MEMORANDUM

SUBJECT: **19 Roszel Road, LLC – Roszel Road Office Buildings
Final Major Site Plan – 2nd Amendment**
Block 9, Lot 62
19-21 Roszel Road
PB 06-01 (2nd Amendment)

Subject: 19 Roszel Road LLC 2nd Amendment
Amended Final Site Plan Review
Block 9 Lot 62
21 Roszel Road

SUBJECT: 19 Roszel Road – Final Major Site Plans & Sign Waiver
Planning Board Review Memo #1
PB06-01 Second Amendment
21 Roszel Road
Block: 9, Lot 62, Tax Map Sheet 8.01 & 8.02
West Windsor Township, Mercer County, New Jersey

Figure 3A

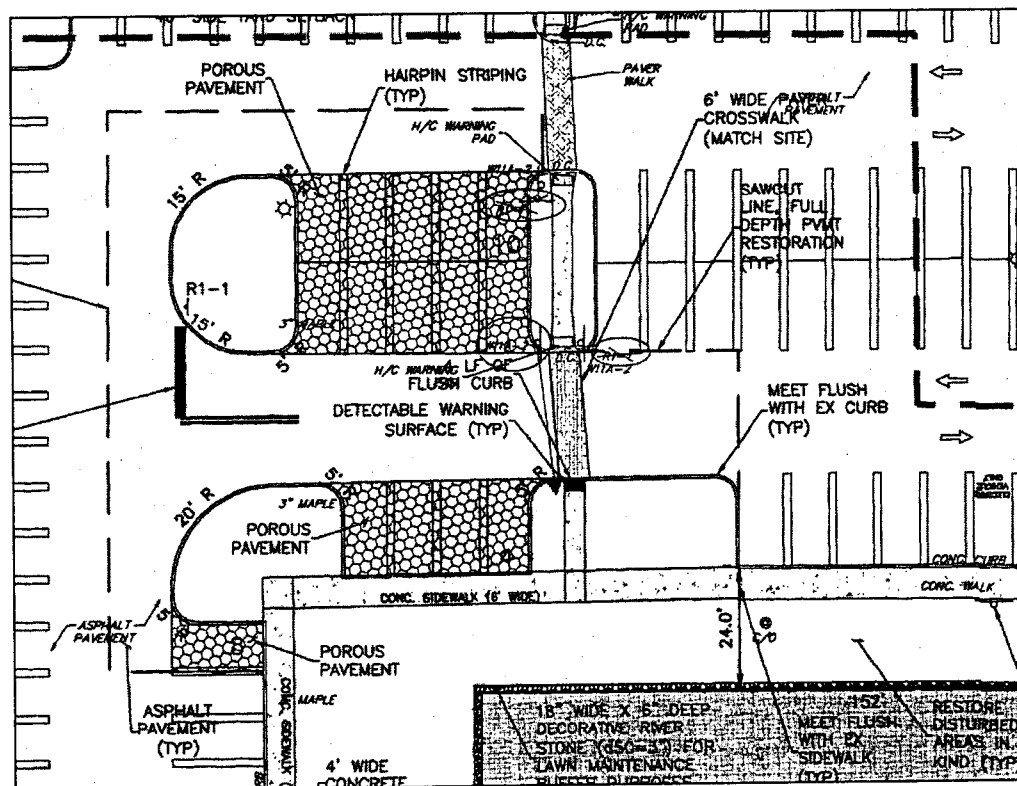
- On Sheet #16, the Accessible Parking Striping Layout shows 'concrete bumper curbs' being placed in accessible spaces. As per Township requirement, we request the Applicant to please replace the 'concrete bumper curbs' with 'bollards'. As per requirement, we also request to label this revised detail to indicate that 'concrete bumper curbs' are being removed and replaced with 'bollards'.
- On Sheet #3 and Sheet #5, we request the Applicant to please revise the labeling, orientation and location of all signs as depicted below in red-line markups in Figures 3A through 3D.
